# ETE Road Map

## Item 6 Site Seismicity

### Preliminary Monitoring Report

Report to the Federal Ministry of Agriculture,  
Forestry, Environment and Water Management  
of Austria

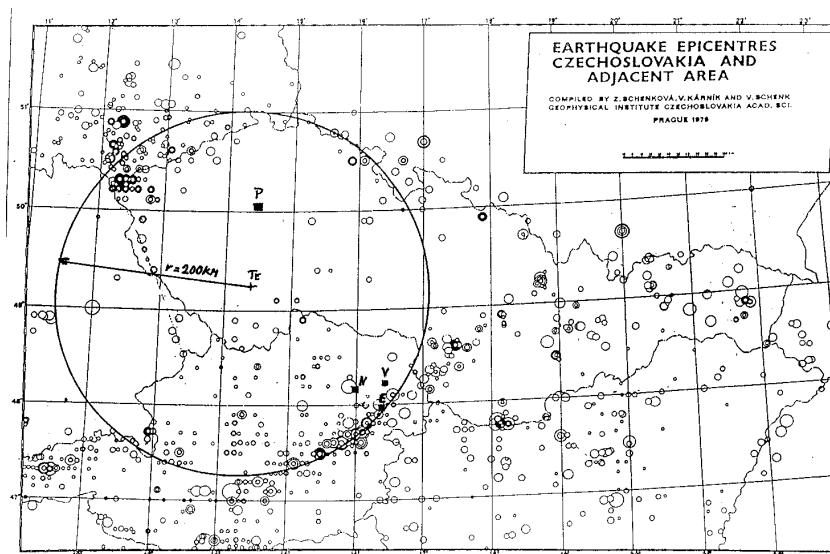
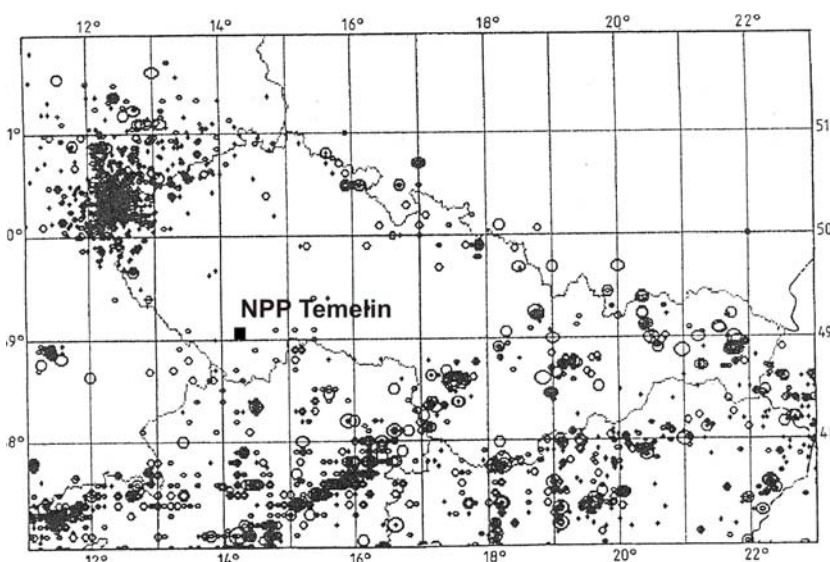
The cited catalogue presently is not available to the Austrian Expert Team and its reliability and completeness therefore cannot be checked directly. cursory comparisons of accessible seismicity maps (compare Figure 2.5.1 a, b); however, show up marked differences between different Czech earthquake databases, which have not been resolved so far. This is illustrated by the seismicity map in compare Figure 2.5.1 b depicting several epicentres around Temelín, which are not included in the other map (compare Figure 2.5.1 a). So far it remains unclear, whether the currently used database by Buben et al. (1999) includes these events or not.

Figure 2.5.4: Seismic source zone model used for the first versions of seismic hazard assessment (Simunek, Energoprůzkum Report Part B, 1995)

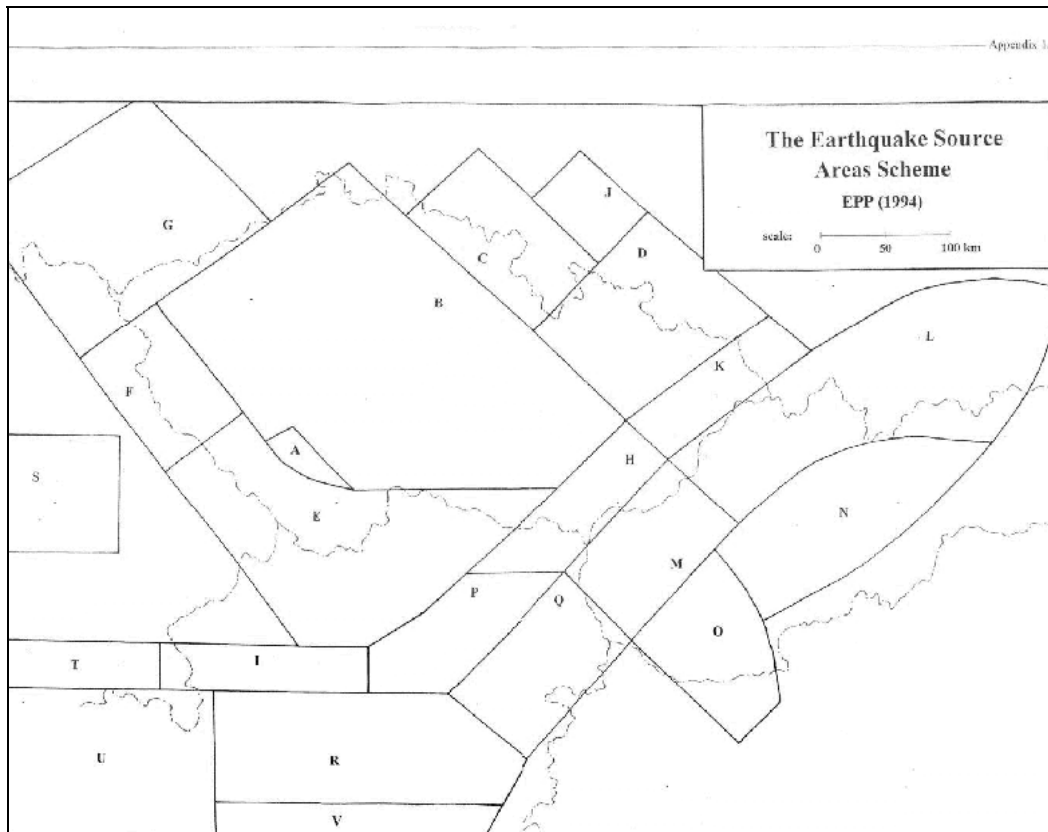
Seismic hazard estimates for Temelín originally have been computed using the source zone model depicted in Figure 2.5.4. The Bohemian Massiv, which is regarded as a mostly homogenous Variscan intra-plate crystalline unit, is divided into seven source zones termed A to E and J (e.g., Šimůnek, 1995). These zones do not obviously relate to geological or tectonic sub-units. This is especially true for the delimitation of source Zone A, which is obviously restricted to the close surrounding of Temelín. Its separation from Zone B is not justified by geological data. The placement of the NPP in a source zone of its own previously was heavily criticised. This zoning was not used in the later probabilistic model, but it remained unclear if it was still used for the derivation of the deterministic hazard assessment.

Figure 2.5.5: Alternative seismic source zone models for Bohemia and the surrounding regions presented by Rudajev during the Workshop at SÚJB Praha, 2003.

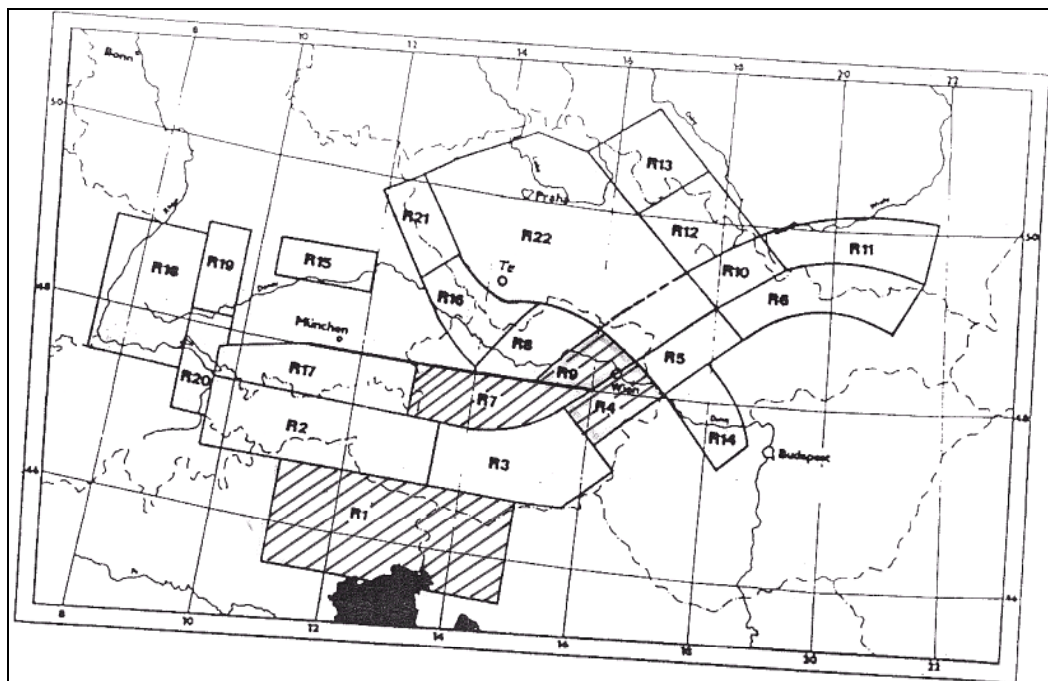
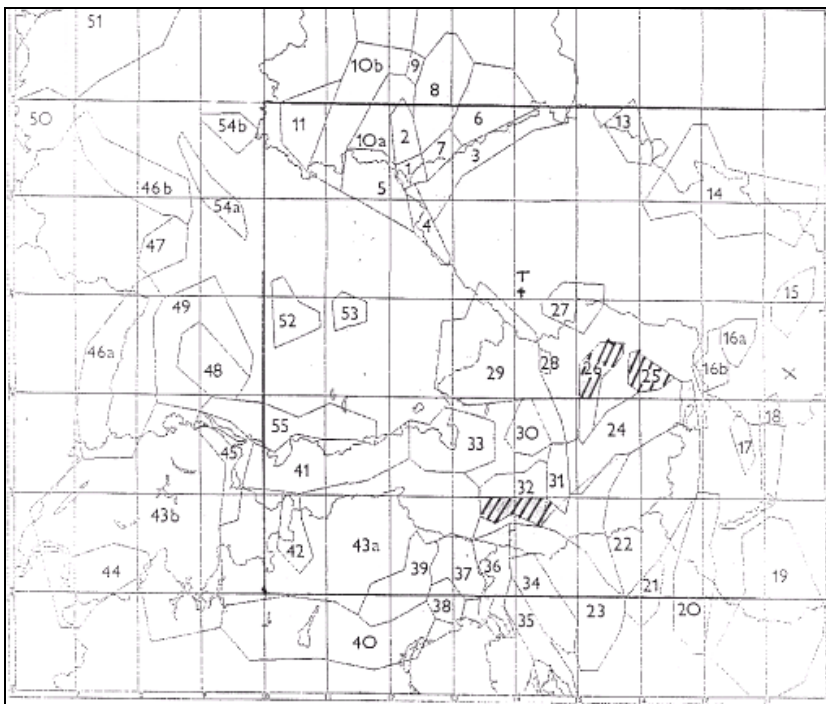
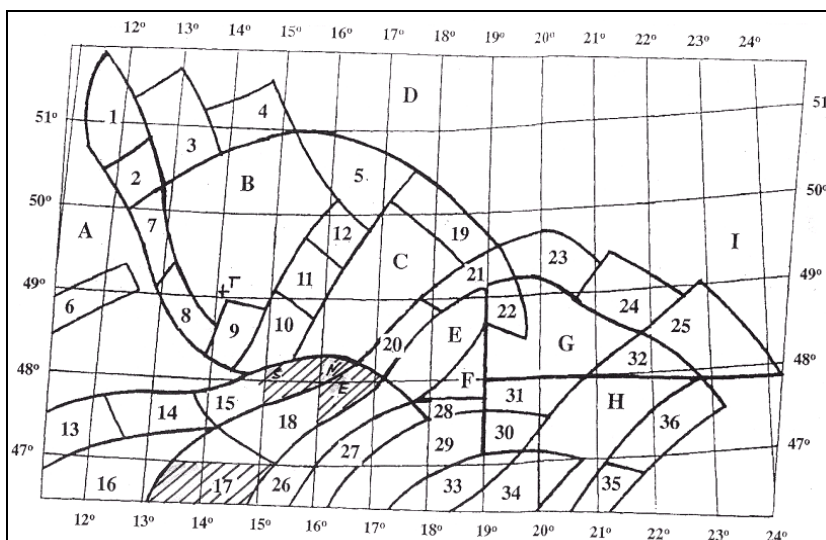
During the Workshop at Praha several alternate source zone models have been presented (Rudajev, Workshop at SÚJB Praha, 2003; Figure 2.5.5), which differ significantly from the originally used model. However, none of the models seems to relate to a reasonable tectonic or seismo-tectonic model (see discussion in Paragraph 2.7.2). According to Schenk (Workshop at SÚJB Praha, 2003), the MCE / SL2 magnitude was calculated for a zone of diffuse seismicity using Gumbel's statistics for a region including entire Bohemia. According to Schenk, this computation confirms the previous results. Rudajev et al. (1998) based their probabilistic analyses on the source zone model depicted in Figure 2.5.5 b.

After the Workshop it remains still unclear whether all the shown models have been used for hazard computations. The effects of changing source zone models on the computed seismic hazard have not been specified. The effects of different source zone models for Bohemia on seismic hazard assessment could only be quantified by re-computation, which could be done with reasonable effort.

Figure 2.5.6: Distribution of micro earthquakes in Austria (ZAMG, 2000) and the Czech Republic (data by Zatobek, 1948; map published by Kutina, 1974).

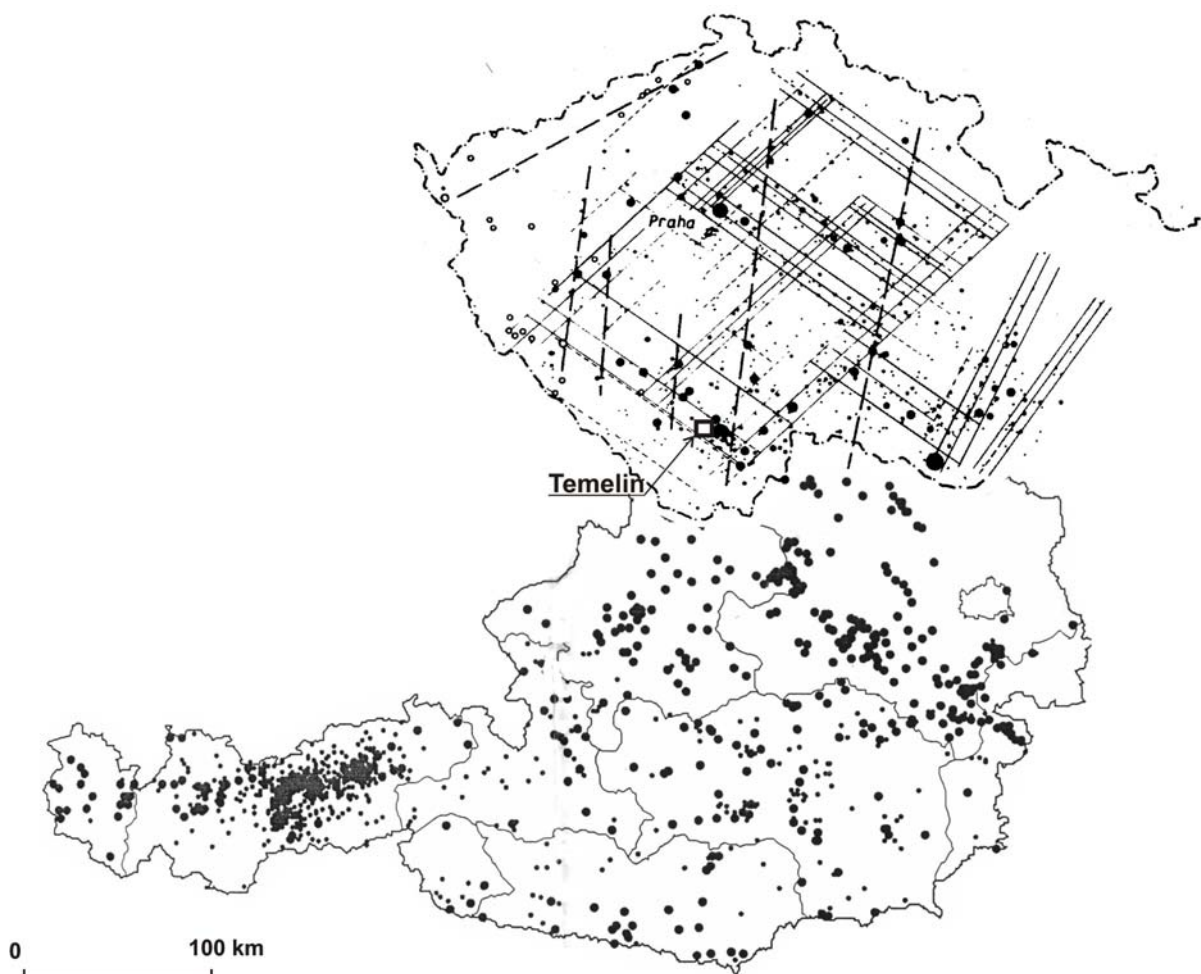
A cursory review of micro-earthquakes (Figure 2.5.6) indicates that micro-seismicity around the Temelín site may be related to NE-striking geological structures paralleling the elongated Budejovice Basin. As far as it can be judged from the available documents, the depicted patterns of micro-seismicity have not been explored in order to identify potentially active and seismogenic fault zones.

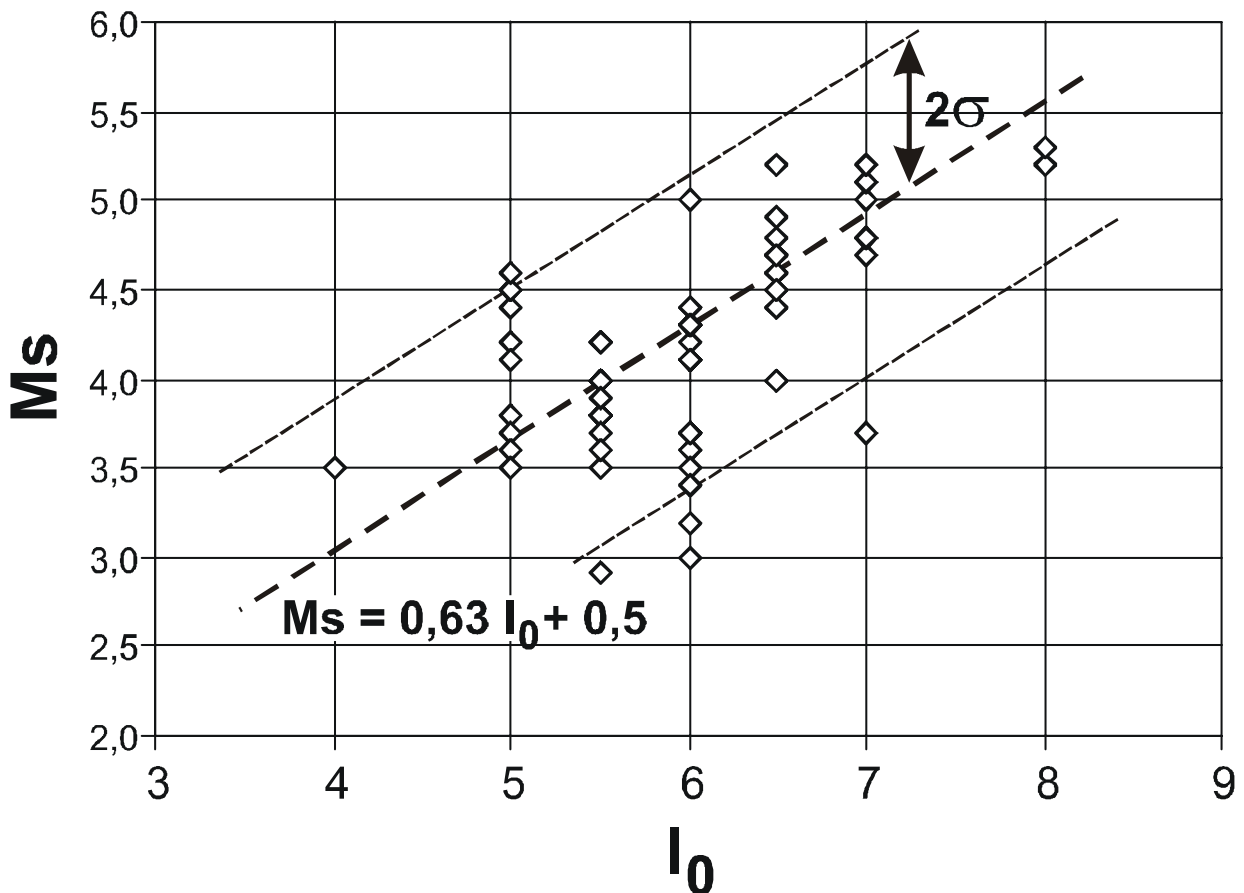
It is concluded that the used simple intensity-magnitude conversion is not adequate and may only be used under consideration of the big uncertainties connected with the formula. This could be done by adopting probability functions, or by using a more “conservative” conversion such as the one shown in Figure 2.5.8.

Figure 2.7.3: Map of faults in the near-region of the Temelín NPP (Buben et al., 1999).

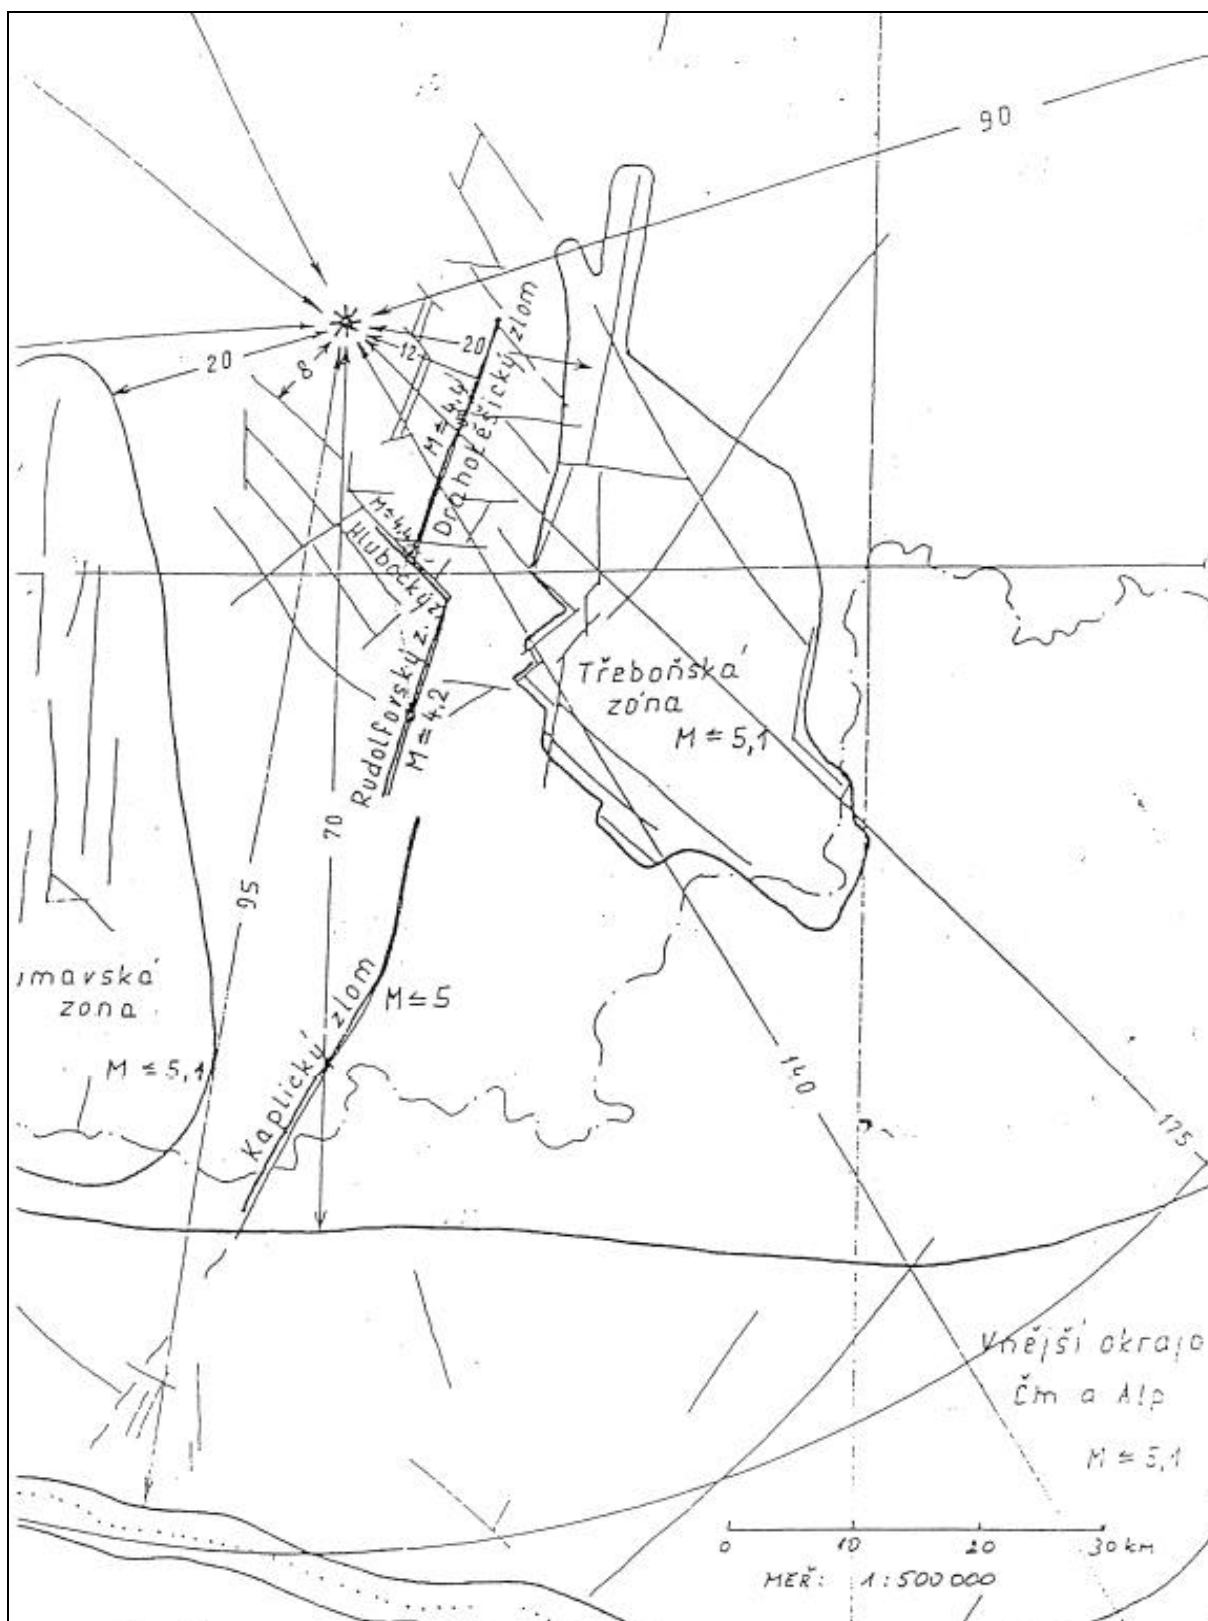
Two maps of potential seismogenic faults are shown in the accessible material (Figure 2.7.2, Figure 2.7.3). The maps differ in a remarkable detail concerning the faults named as Fault 1.5 (Jachymov Fault) and Fault 1.2.1 (Kaplice Fault) shortly south of the NPP (Figure 2.7.2). In the map on Figure 2.7.2, which is used for the computation of MCE’s for each of the depicted faults by an Expert System (see Paragraph 2.10.1), the faults terminate about 25 km SSE of the NPP. The map in Figure 2.7.3 shows Fault 1.2.1 passing about 10 km E of Temelín and Fault 1.5 terminating at a distance close to the power plant. Both maps depict no other faults in the near region of the NPP, although several major faults in the near-region exist (compare the map in Figure 2.7.4). Also, both maps do not include the boundary faults of the Cretaceous basin of České Budejovice shortly south of the Temelín site.

Figure 2.7.4: Tectonic map of the near-region of the Temelín NPP (Simunek, 1995).

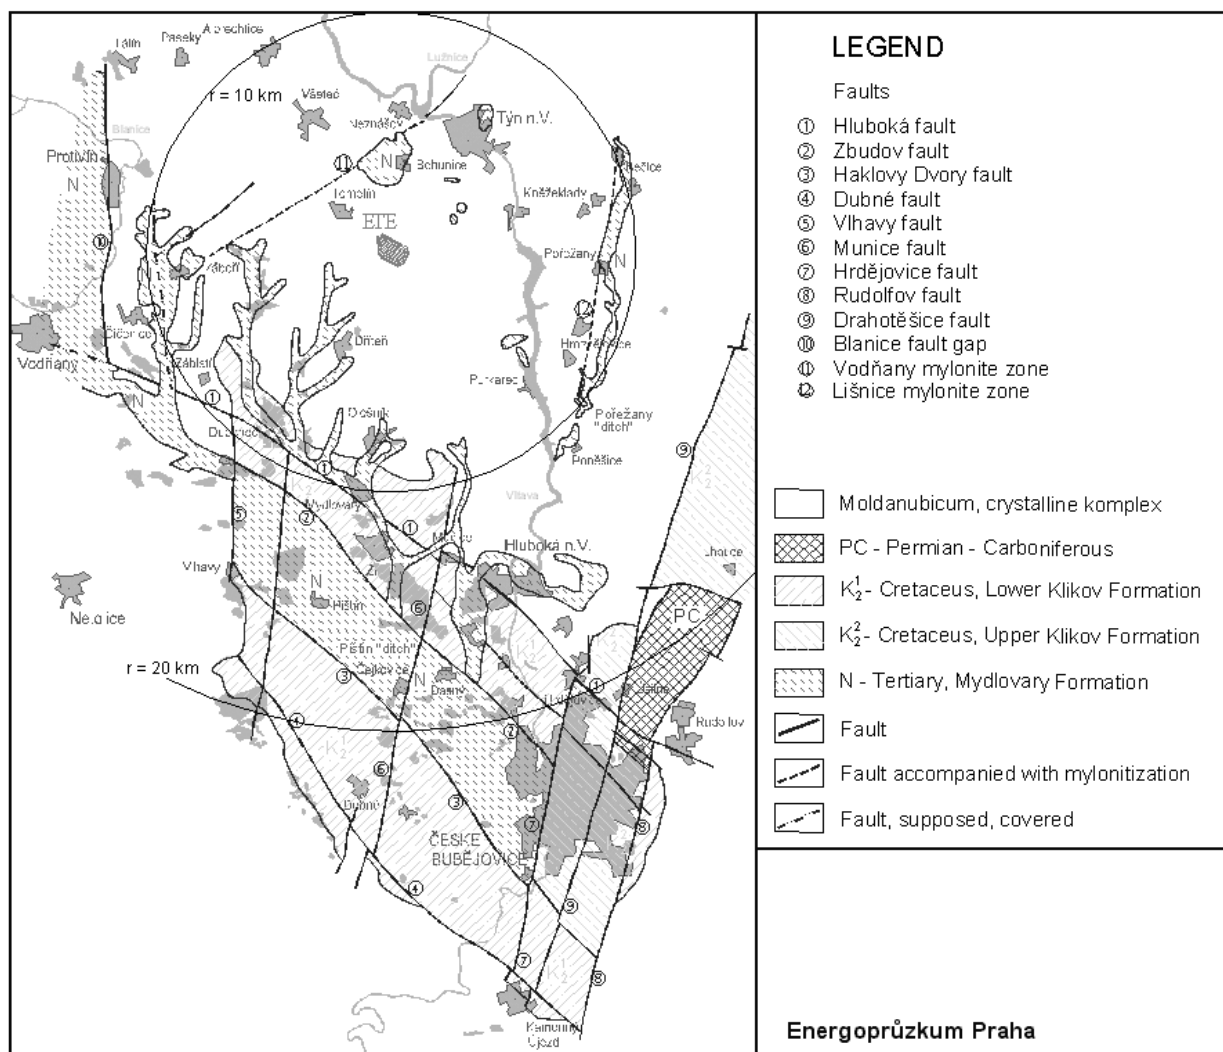
investigated by cursory geological investigations (see Paragraph 2.7.4). Despite of distinct geological evidence some of the faults, for which MCE's have been computed, are not traced into the near region (compare Figure 2.7.4 and Figure 2.7.2).
